**STAFF RECOMMENDATION**

**2602 Essex Place**

**Application:** New Construction—Addition

**Description of Project:** Application for the construction of a rear addition, including a ridge raise.

Figure 4: Note window and door alterations

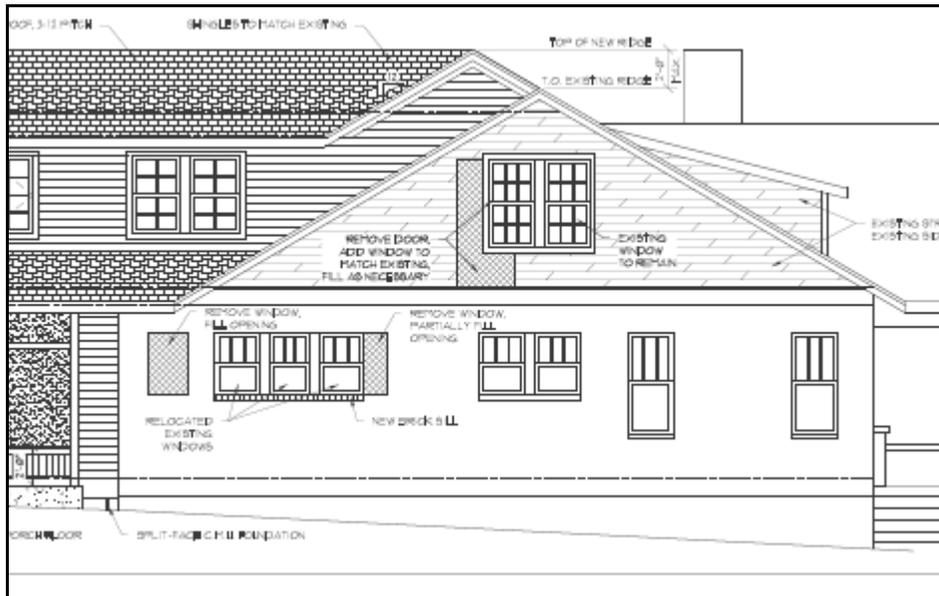
**Demolition:** An existing rear screen porch and the rear wall of the house will be removed in order to attach the new rear addition. (See Figure 2.) This area is not visible from the street, and does not contain any significant architectural features. Staff therefore finds that the screen porch and rear wall do not contribute to the architectural and historical character and significance of the district, and that the proposed partial demolition meets Section III.B.2 for appropriate demolition and does not meet section III.B.1 for inappropriate demolition. Further partial demolition work is proposed for the west elevation. Here, a door on the second floor, in the gable field, will be removed and replaced by a window. (See Figure 3.) This was likely the original configuration. Toward the rear of the west elevation, three windows will be shifted slightly, as seen in Figures 3 and 4. As these windows are located beyond the midpoint of the house, and the historic windows will be

re-used, maintaining the historic window proportions, staff finds the proposed partial

demolition to be appropriate and to meet section III.B.2 for appropriate demolition and not meet section III.B.1 for inappropriate demolition.

01 SITE PLAN Scale: 1/8"=1'-0"

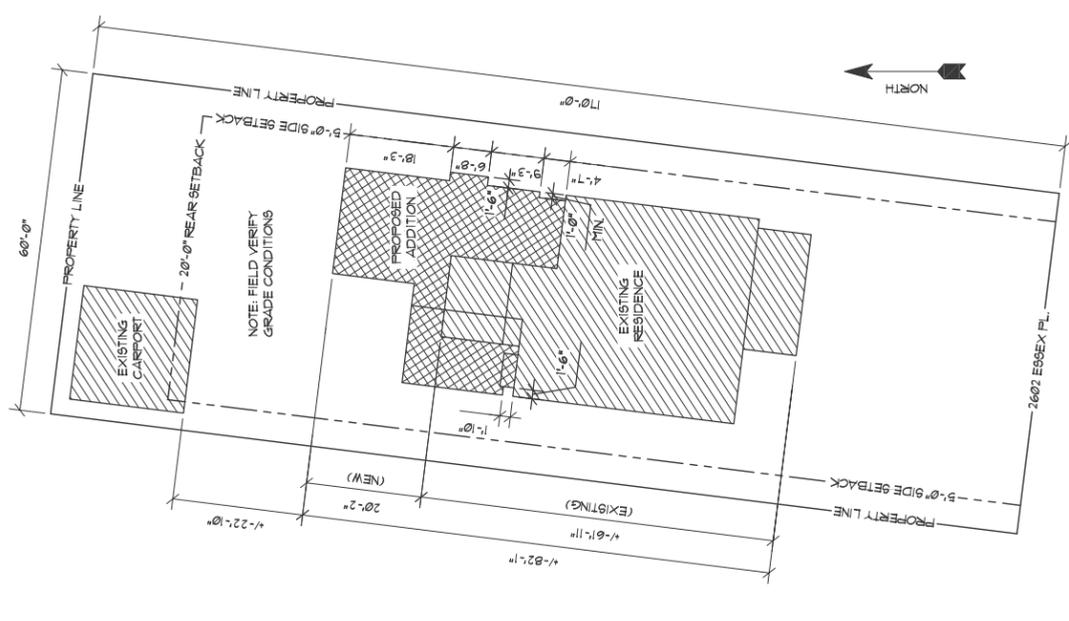
Setback & Rhythm of Spacing: The new construction will not impact the front setback. The west side will not step out any wider than the historic house, which is approximately thirteen feet (13') from the property line. The east side is approximately ten feet (10') from the property line. A small one-story bump-out near the middle of the addition will step one foot, six inches (1'6") closer to the side property line for a depth of six feet, eight inches (6'8"). There is an existing outbuilding on site; the footprint of the proposed addition will be approximately twenty-two feet, ten inches (22'10") from this outbuilding, meeting the required twenty feet (20') separation, as per the design guidelines.

6 FRONT ELEVATION (SOUTH)

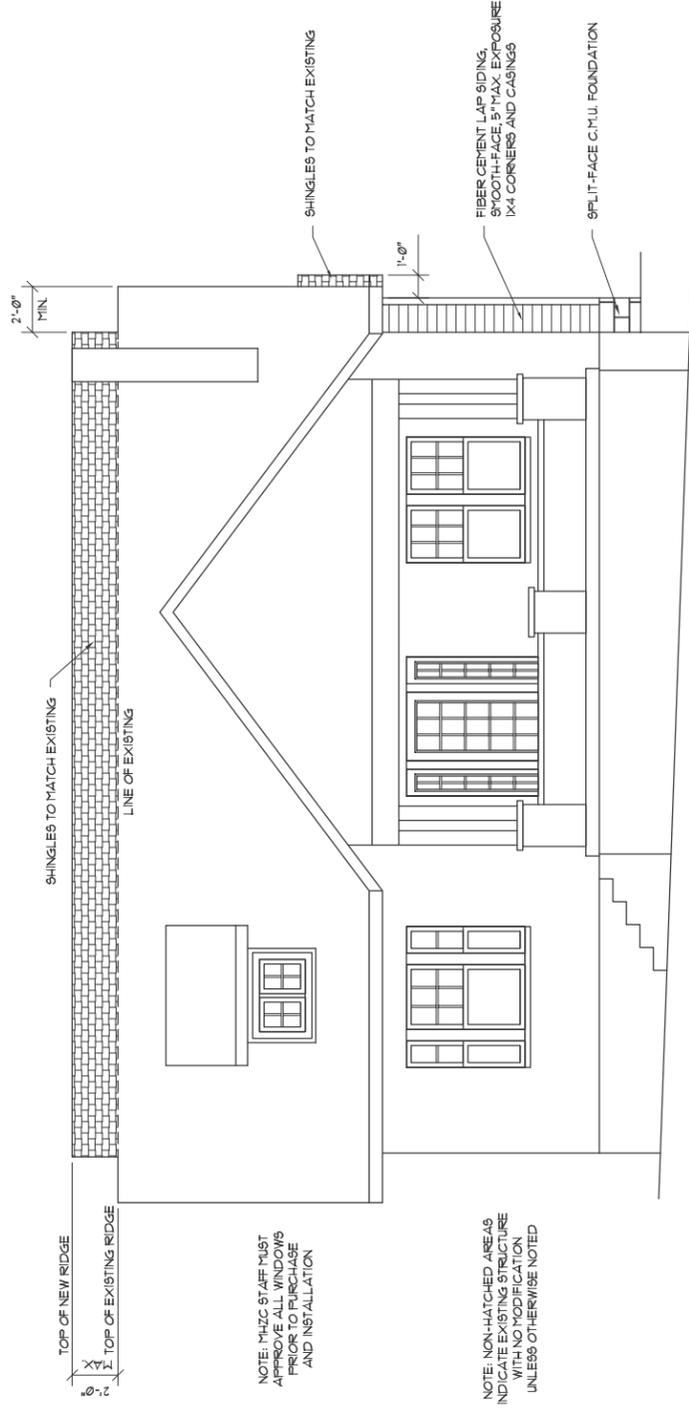
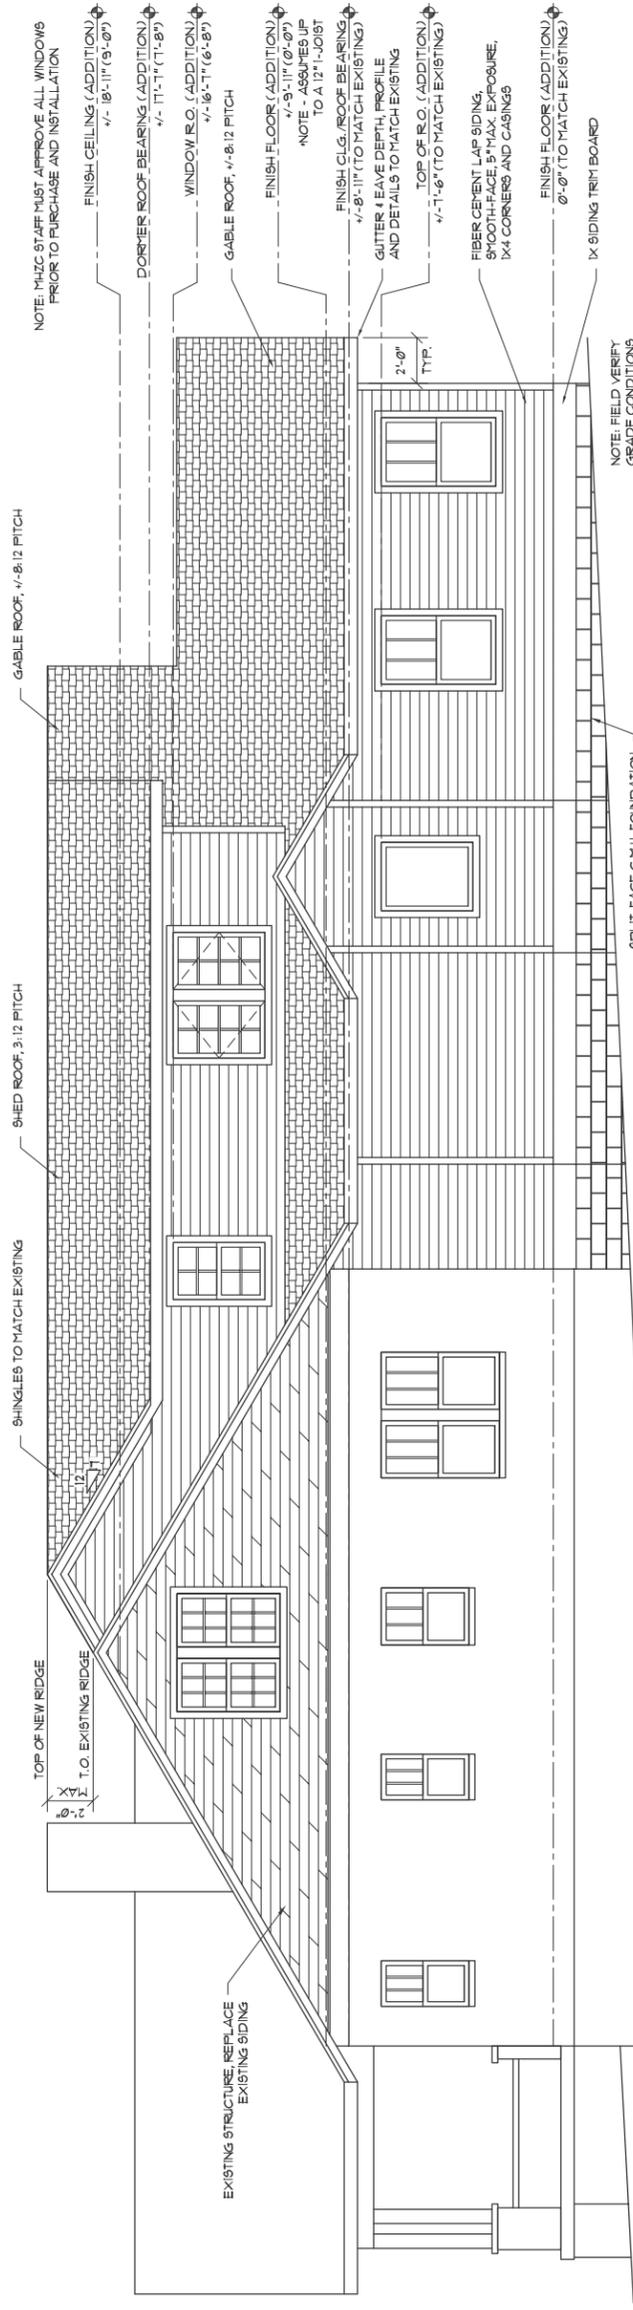
Roof form: The historic house has a side gabled roof with a 7/12 slope. The addition utilizes a ridge raise. As per the guidelines, the side gabled ridge raise steps up two feet (2') in height and steps in two feet (2') on both sides. The slope matches the historic house at 7/12. A rear gabled portion has an 8/12 slope. The roof form and slope is compatible with the historic house. The project meets section II.B.1.e.

Proportion and Rhythm of Openings: The windows on the proposed addition are all generally twice as tall as they are wide, thereby meeting the historic proportions of openings. There are no large expanses of wall space without a window or door opening. Staff finds the project's proportion and rhythm of openings to meet Section II.B.1.g.

02 LEFT ELEVATION (WEST)

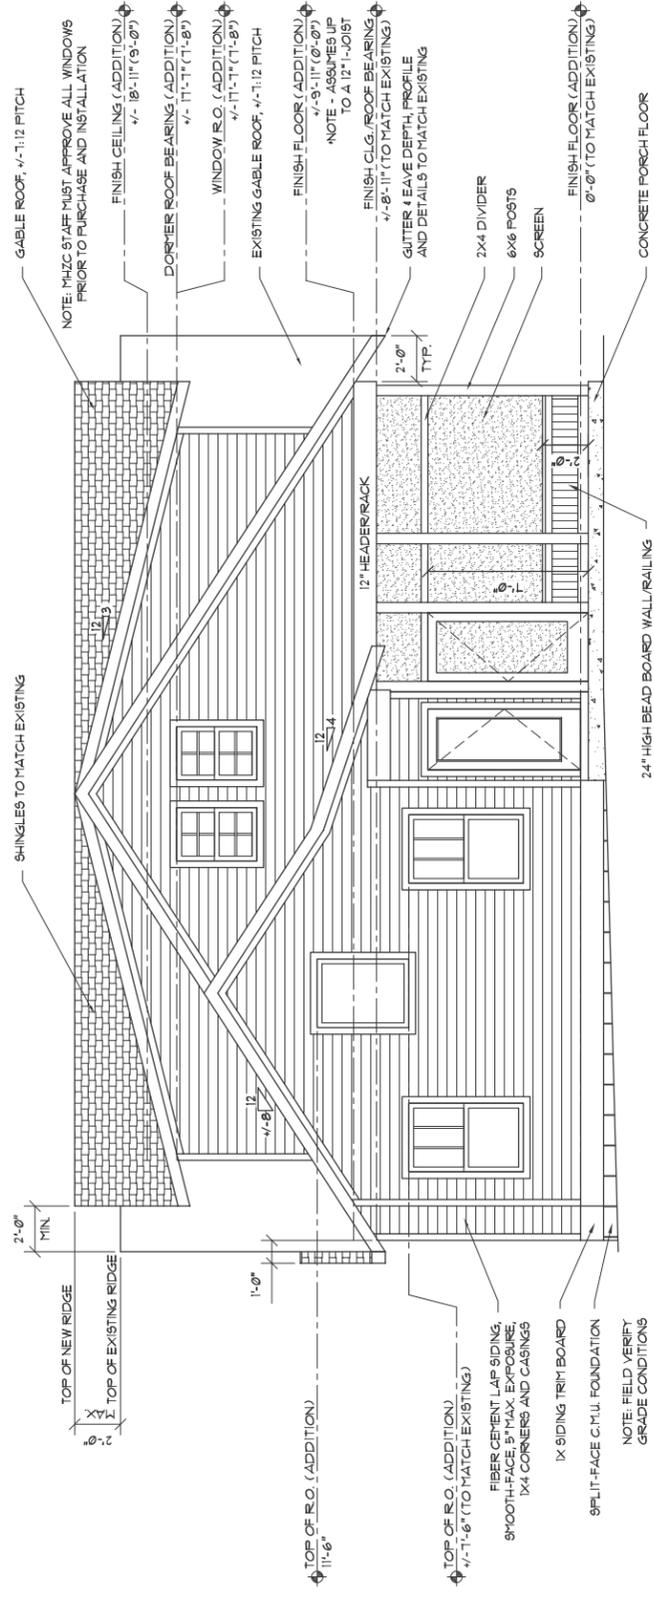
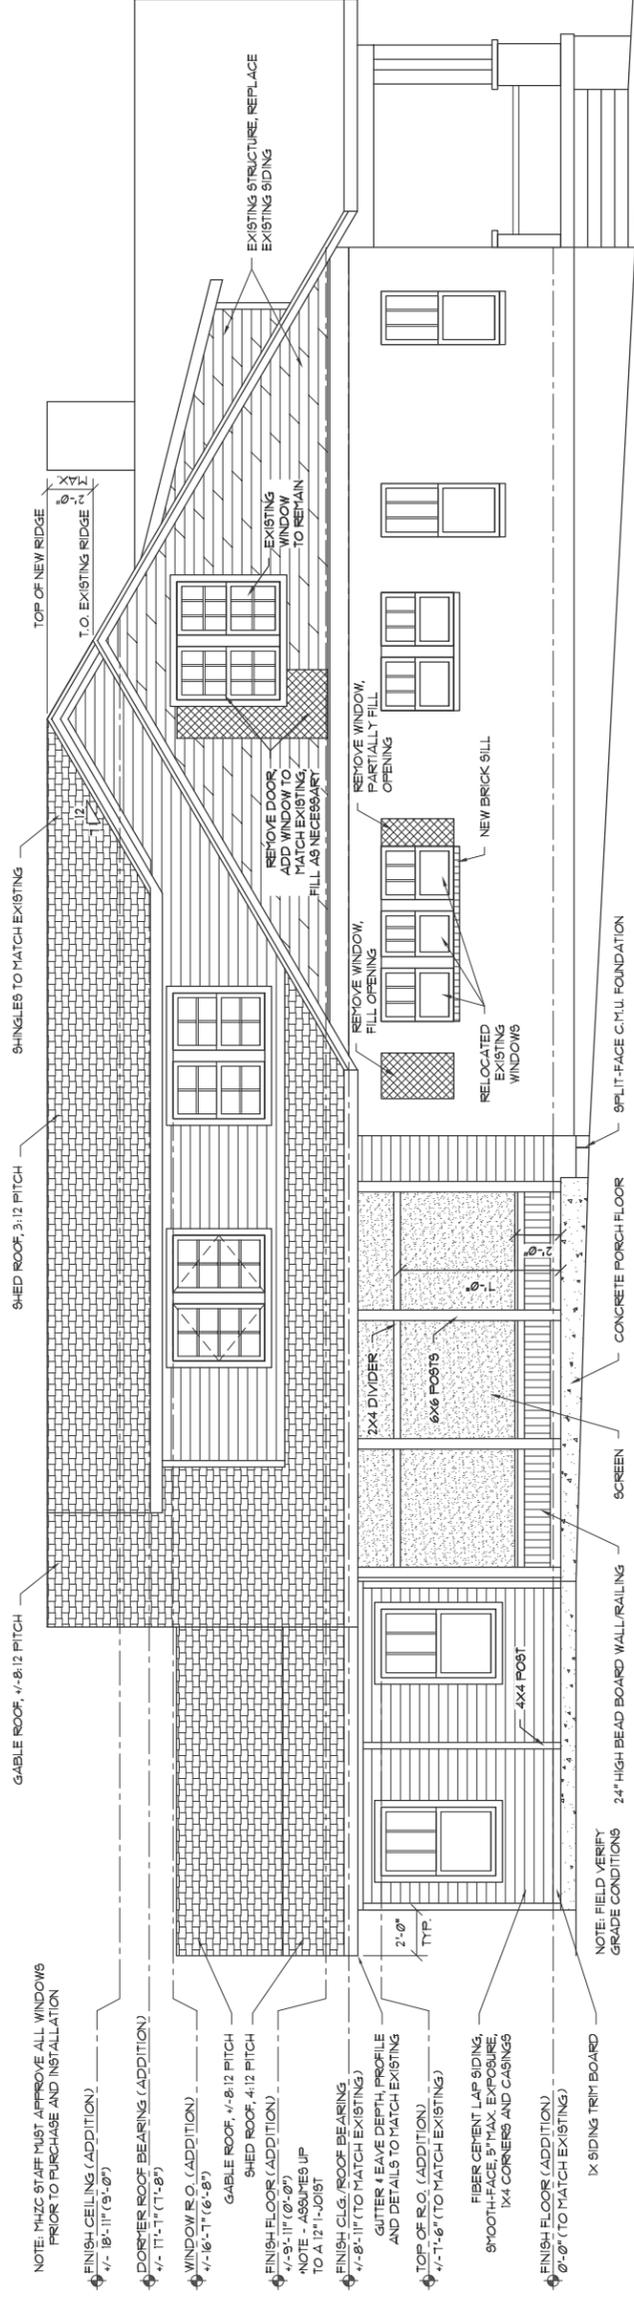
Height & Scale: The ground level of the addition will be inset one foot (1') and then will step out to be the same width as the historic house. The second floor will be narrower than the existing house, being inset by two feet (2') for its full depth. Staff finds that the addition is compatible in width and meets the design guidelines.
